# Access Compliance Report

## Public Rights-of-Way

### (Curb Ramps)

Intersection ID: 10031176	Main Street: MARK_PL	Cross Street: N/A	Location:	N
ADA ID: EE81C80F4E57	Ramp Type: BlendTrans1	Initial Pass/Fail: Fail	Overall Compliance: No	Severity Score: 25

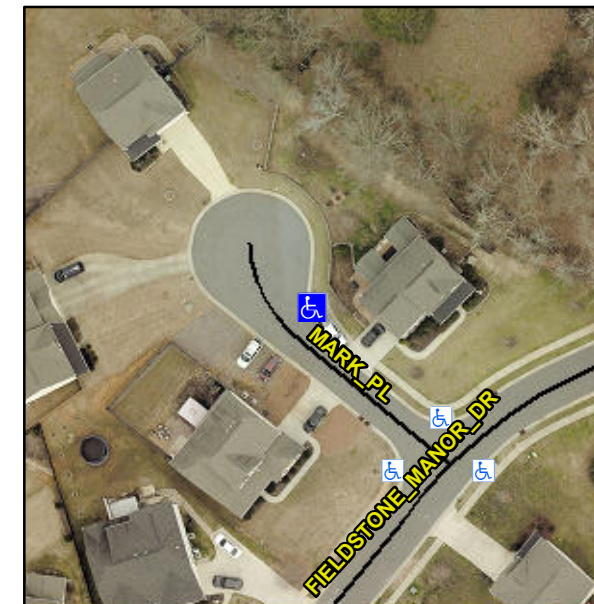
**Not Found, R304.5.3**

Compliance	Description	Data	Compliance	Description	Data
N/A	Ramp Length (in)	47.5	Yes	BlendTrans Slope (%)	4.4
Yes	Ramp Width (in)	69.0	No	BlendTrans XSlope (%)	9.2
N/A	Flare Type LT	N/A	N/A	Flare Type RT	N/A
N/A	Flare Slope LT (%)	N/A	N/A	Flare Slope RT (%)	N/A
N/A	Flare Traversable LT?	N/A	N/A	Flare Traversable RT?	N/A
N/A	Landing Length (in)	N/A	N/A	DWS Provided?	N/A
N/A	Landing Width (in)	N/A	N/A	DWS Contrast?	N/A
N/A	Landing Slope (%)	N/A	N/A	DWS Length (in)	N/A
N/A	Landing X Slope (%)	N/A	N/A	DWS Full Width?	N/A
N/A	Landing Curb? (Y/N)	N/A	N/A	DWS Offset (in)	N/A
N/A	Shared Landing?	N/A			
N/A	Gutter Ponding?	N/A	N/A	Gutter Slope (%)	N/A
N/A	Gutter Lip Ht (in)	N/A	N/A	Gutter X Slope (%)	N/A
N/A	Painted X Walk1?	No	N/A	Painted X Walk2?	N/A
	X Walk 1 Direction	To W		X Walk 2 Direction	N/A
	X Walk 1 Width (in)	N/A		X Walk 2 Width (in)	N/A
	X Walk 1 Slope (%)	7.1		X Walk 2 Slope (%)	N/A
	X Walk 1 X Slope (%)	4.3		X Walk 2 X Slope (%)	N/A

**Remove & Replace Curb Ramp With Two New Directional Ramps or Equivalent.**
